SCHOOL DEVELOPMENT STANDARD DEPARTURE ADVISORY COMMITTEE

WING LUKE SCHOOL DESIGN DEPARTURE RECOMMENDATIONS

Project #3027255

April 17, 2018

Exhibit 3 Proposed Height

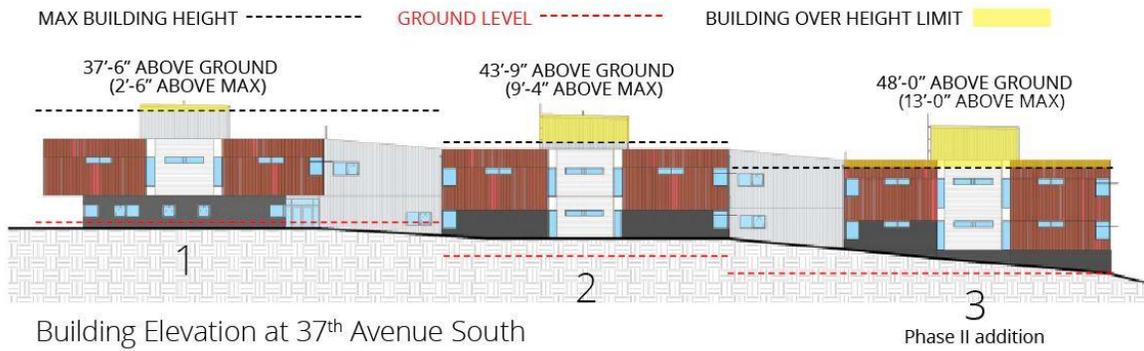
Departure Requested: 9 feet 4 inches above the height limit.

The committee challenged the design team to find a way to reduce the height of the building, such as excavating further to lower the base of the buildings. The proposed Phase 2 was the height the committee was most unhappy with. Because this Phase is not yet funded, and departure is not yet needed, the committee recommended deferring granting a departure for this portion of the building until SPS proposes to build it.

The mechanical space on the roof of the proposed Phase I buildings exceeds the maximum allowable height, and part of the building in addition to the mechanical space on the Phase II addition exceeds the maximum allowable height (See exhibit 3). The Committee understands the need to locate the mechanical space on the roof rather than in the building or on the ground, and with a thoughtful design of the enclosures, the impacts of the additional height can be mitigated.

Comments from Dale Bamford: Mr. Bamford asked if the height equipment could be lower. He mentioned that traffic in 37th is already congested and he is concern about safety because people are driving too fast. He added that having a sign in place may open the door of other signs around the neighborhood. He asked if SPD (Seattle Police Department) has been consulted or involved in the process since there have been various activities in the school yard in the past.

Mr. Love commented that the materials they are going to use for the mechanical penthouse will be durable, fiberboard and paintable. It will be a lighter color that projects a less bulky and massive structure. He added that the rooftop location of the mechanical penthouse is fixed. Any other location will be expensive, and this configuration reduces the footprint of the building.

Mr. Cook suggested having trees along Kenyon St. that are tall enough that will distract the view of the penthouse. Ms. Godard commented that is a condition that the Committee can add that reduces the scale of the building and provides a transition from the large structure.

Recommendation 1 – That the departure to allow greater than allowed building height be GRANTED as requested by Seattle Public Schools without modifications and with the following conditions:

- a. **The proposed addition be limited to only Phase I. Phase II, requiring the most significant height departure, should be reviewed, if required at the time, by a departure committee when the School District is proposing to construct it.**
- b. **Consider types of trees and landscaping that will obscure additional height of the building.**

- c. **When designing the enclosure for the mechanical space on the roof, the design team should consider using a light color and texture so as not to draw attention to the structure or make it look too industrial.**

Exhibit 6 Proposed Message Board

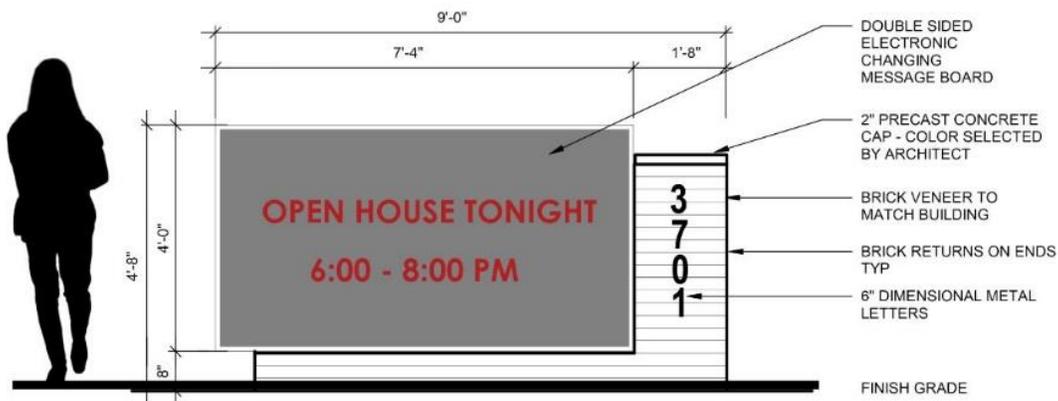
Departure Requested: To install a double-sided, electronic, changing image message board.

The Message board was viewed by the committee as a helpful tool in sharing school announcements with the community in multiple languages.

Ms. Boothby commented that she does not like having bright lights in a quiet neighborhood. She added that traffic is bad, and parents are already parking in their driveways, and it may become worse with the new school.

Ms. Boothby commented that she does not mind the electronic message board. She added that there should be a condition to turn off the messaging board earlier.

Ms. Godard commented that from her experience from previous school departures, the neighborhood chose not to have signs. This Committee chose to add conditions by limiting the hour of usage, change in text color, or reducing the size of the message board.

Ms. Sheehan commented that what she heard from the public comments are setting a precedent for having electronic signs in the neighborhood, limiting the height, hours and days of operation due to light pollution. Mr. Skutack added about the choice of color of the signs to limit visibility.

Ms. Tsai also added to limit the electronic board to just one and there will be no additional signs around the school.

Mr. Cook mentioned about a comment that it will only allow text display and no graphics.

Recommendation 4 – That the departure to allow an electronic message board be GRANTED as requested by the Seattle Public Schools without modifications and with the following conditions:
